TRANSMITTAL OF VARIANCES TO PROJECT SPECIFIC PLANS

VARIANCE / FIELD CHANGE NOTICE

PROJECT TITLE: PSP for the Area 3 Pre-design Investigation of Plant 9

PROJECT TITLE: PSP for Area 3 Pre-Design Investigation of Potentially Characteristic Areas

STATE PLUMBER COORDINATE SYSTEM 1983 20-SEP-1998
 FIGURE 2-4. EXISTING RI/FS DATA AND NEW SAMPLING LOCATIONS FOR SCRAP METAL PILE AREA

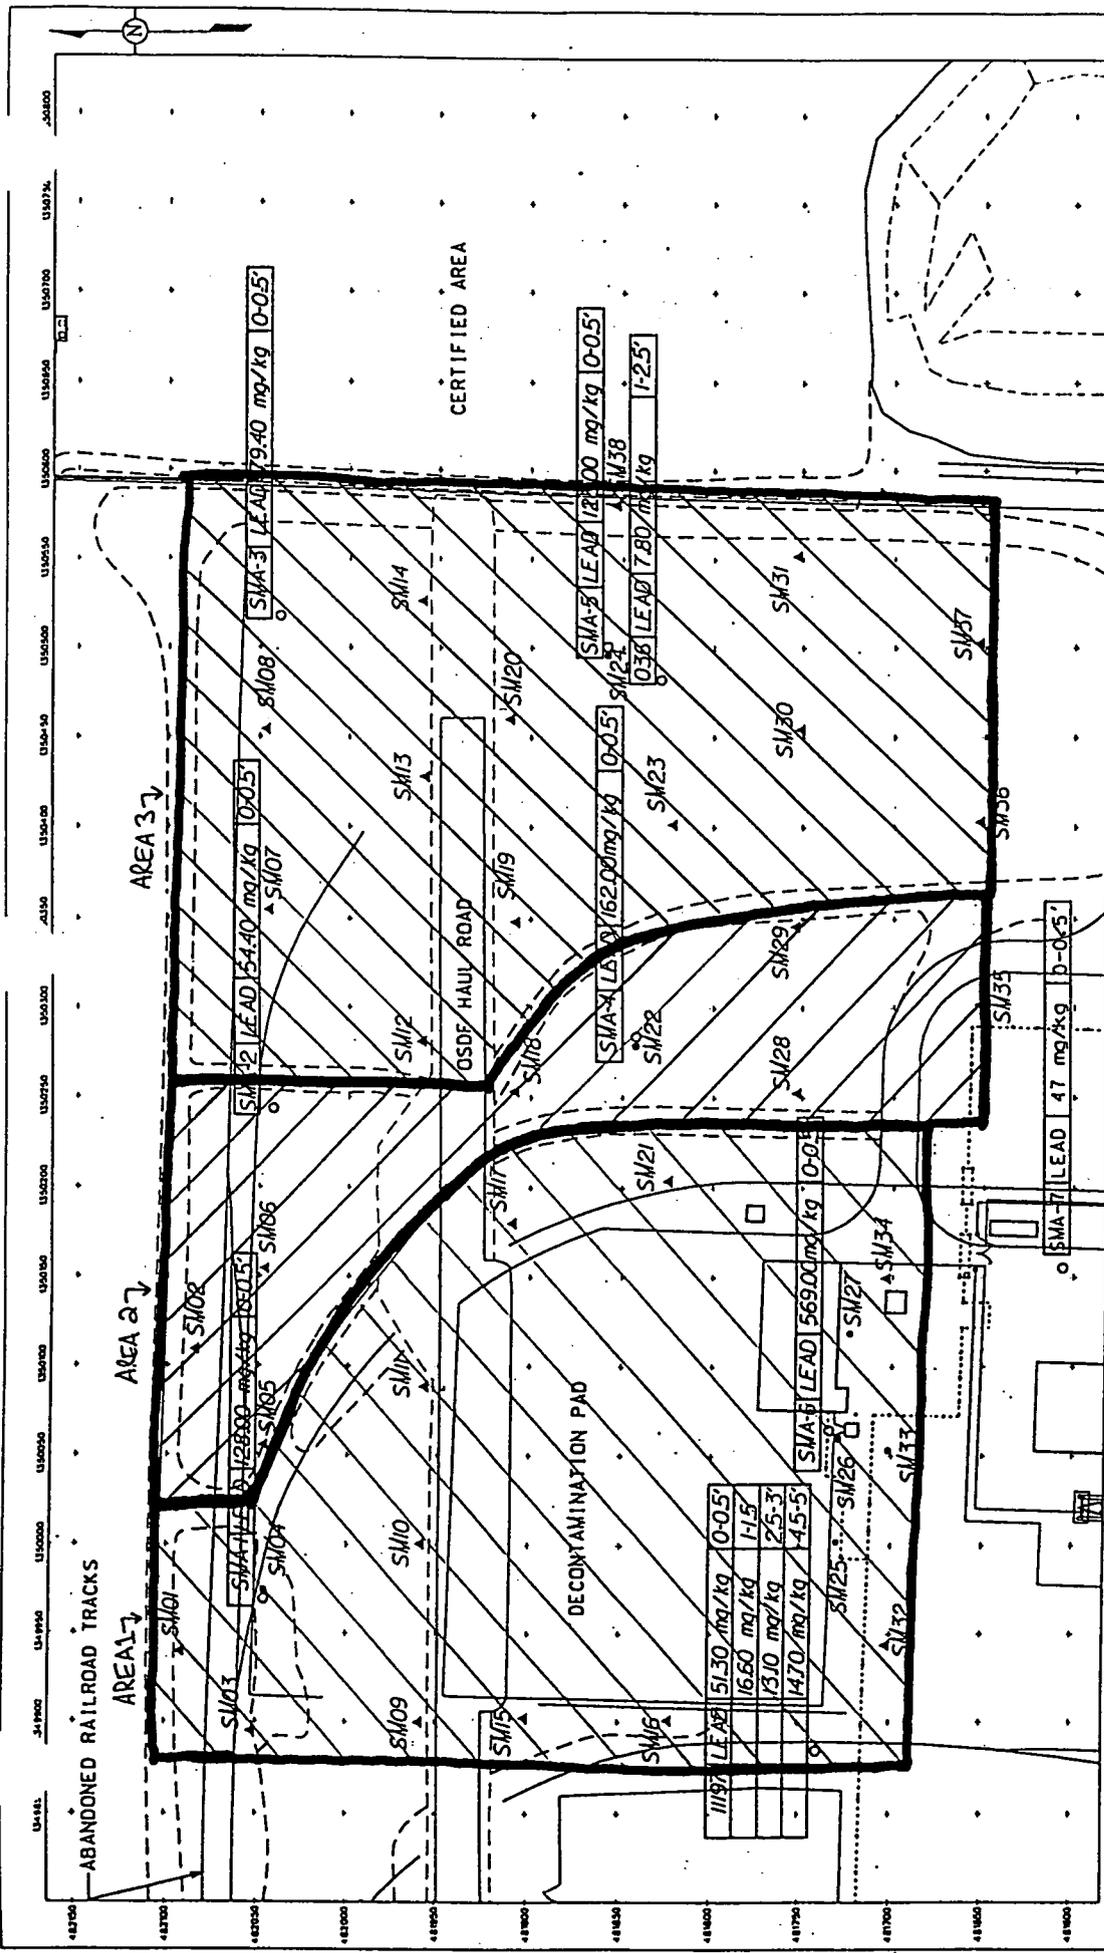
Comment: The text states that samples will be collected for Toxicity Characteristic Leaching Procedure (TCLP) analysis at locations where remedial investigation sampling results for total lead concentrations exceeded 20 times the TCLP limit. Based on the TCLP results, a total lead screening level will be established for each area that reflects that highest total lead result for samples that pass the TCLP limit of 5 mg/L in that area. However, this screening level would be valid for each area only if the lead compounds throughout the area are the same as the lead compounds in the samples whose TCLP results were used to establish the lead screening level. If lead compounds within an area are more soluble than the lead compounds present at the sampling locations used to establish the lead screening level, the screening level could be too high. Samples with total lead concentrations below the screening level could actually have a TCLP limit that exceeds 5 mg/L.

Unless there is adequate site history information to determine the chemical nature of the source of the lead and its current chemical state after degradation, the screening level of 100 mg/kg of total lead or 20 times the TCLP limit of 5 mg/L should be used.

However, the Scrap Metal Pile area is large (the entire northeast corner of the Former Production Area) and is known to have had multiple uses. Based on historical aerial photographs of the site, the Scrap Metal Pile area has been subdivided into three areas to address EPA's concerns (see revised Figure 2-4). Area 1 is defined by the area used to store scrap metal and includes the Decontamination Pad and the surrounding area; Area 2 is directly to the east of the Decontamination Pad and was used to store drums; Area 3 borders the eastern boundary of the Former Production Area and was an area of disturbed soil. Each of these subareas includes at least one location undergoing TCLP analysis in the current PSP.

Response: DOE agrees with EPA's statement that the total lead screening level would be valid for each area only if the lead compounds throughout the area are the same as those in the TCLP samples used to establish the lead screening level. Due to the small size of the lead contamination area near the KC-2 Warehouse, no changes will be made to the screening level strategy presented in the Project Specific Plan for that area.

Because Areas 2 and 3 of the Scrap Metal Pile Area and Area 2 of the Maintenance Building Area have only one sample being collected for initial TCLP analysis, at least the sample with the highest total lead concentrations above the 20-times limit will also undergo TCLP analysis

DOE believes that further subdividing the Scrap Metal Pile area and the Maintenance Building area, as described above, will ensure that total lead screening levels are established using TCLP results that are valid and comparable within those subareas.

Action: The PSP will be revised to reflect these changes prior to laboratory analysis of samples.

FIGURE 2-5. EXISTING RI/FS DATA AND NEW SAMPLING LOCATIONS FOR MAINTENANCE BUILDING AREA

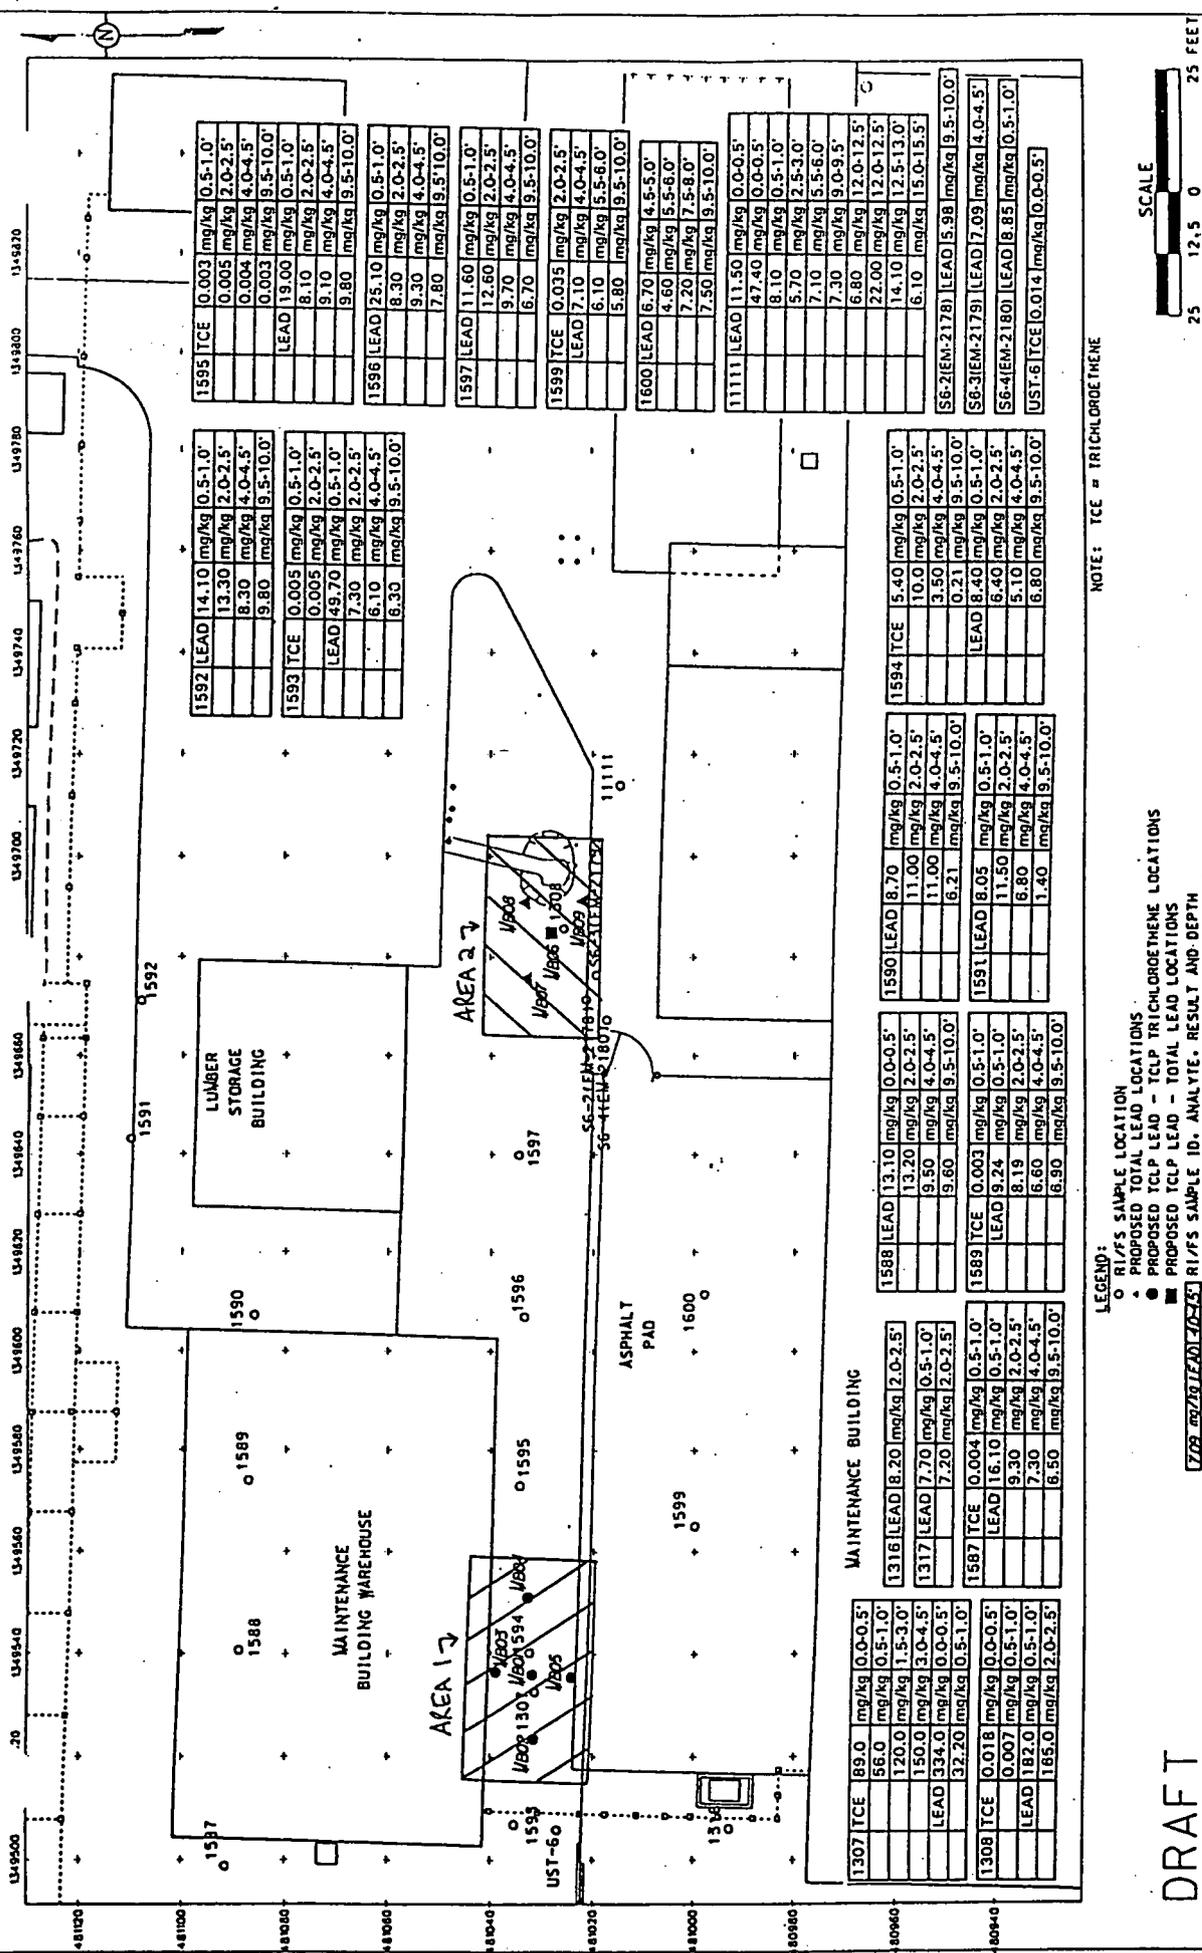
Although the lead contamination north of the Maintenance Building does not cover a large area, there are two distinct areas of contamination and only Area 1 is associated with elevated levels of trichloroethene contamination. Therefore, the area north of the Maintenance Building has also been subdivided into two areas of contamination (see revised Figure 2-5). Screening levels will be established and compared only within those subareas.
